Ritewood Egg
Generator Building
November 2021

Daniel Tanner 819 N. 2400 W A-10

Proposed Subdivision Application

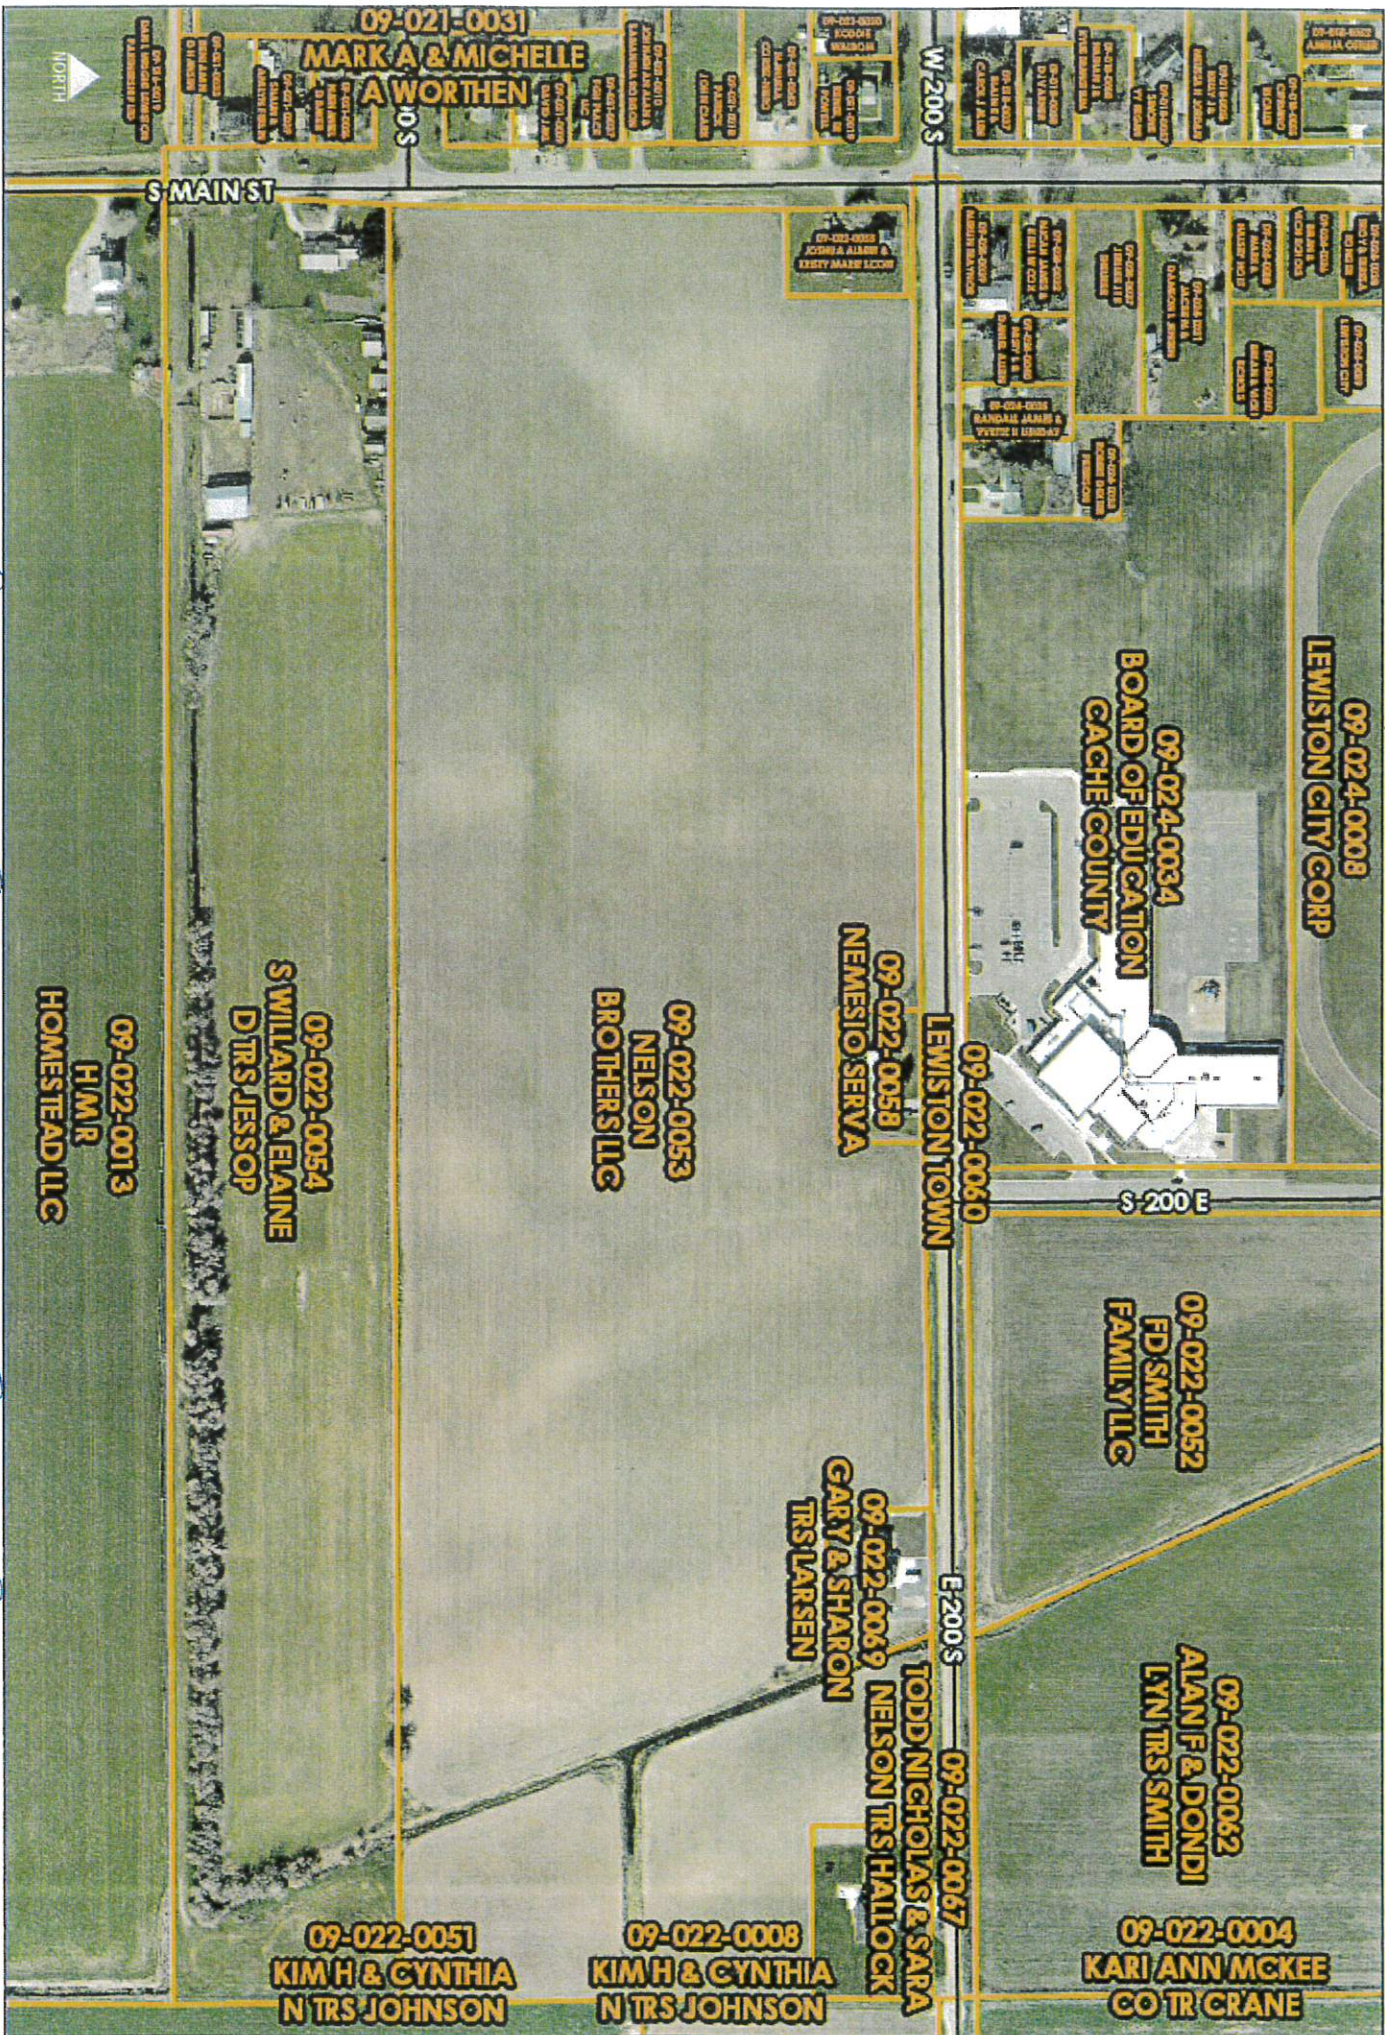
3. Lewiston City Code § 11-3-4(B)(2) requires the Final Plat to contain the “endorsement . . . by every person having a security interest in the subdivision property that they are subordinating their liens” In this case, the Title Report indicates there is a trust deed in favor of Cache Valley Bank on title. Thus, the City should ensure that Cache Valley Bank signs the Final Plat thereby subordinating its interest to the easements and dedications set forth on the Plat. Another acceptable method of approaching this issue, and one that is more common, is to have the developer provide a partial release of the trust deed from the Bank that can be recorded contemporaneously with the Plat. The City should ensure either one of these options is done before approving the Plat.

4. Lewiston City Code § 11-3-4(D) requires that all signature blocks are signed before recording the Plat. The signature block for the attorney indicates that we have reviewed guarantee documents for the subdivision, but we have not. If there are financial guarantee documents for this subdivision then they should be sent to us for review. If there are no financial guarantee documents for this subdivision, then the attorney signature block should simply read as follows: “Approved as to form this ____ day of November, 2021” and then provide a place for signature. The City should ensure change is made before approving the Plat.

9. Lewiston City Code § 11-3-3(C)(28) requires the plat show “a tentative plan or method by which the subdivider proposes to handle stormwater drainage for the subdivision.” We did not see this information on the Plat. The City should determine if this element should be included on the Final Plat before approval.
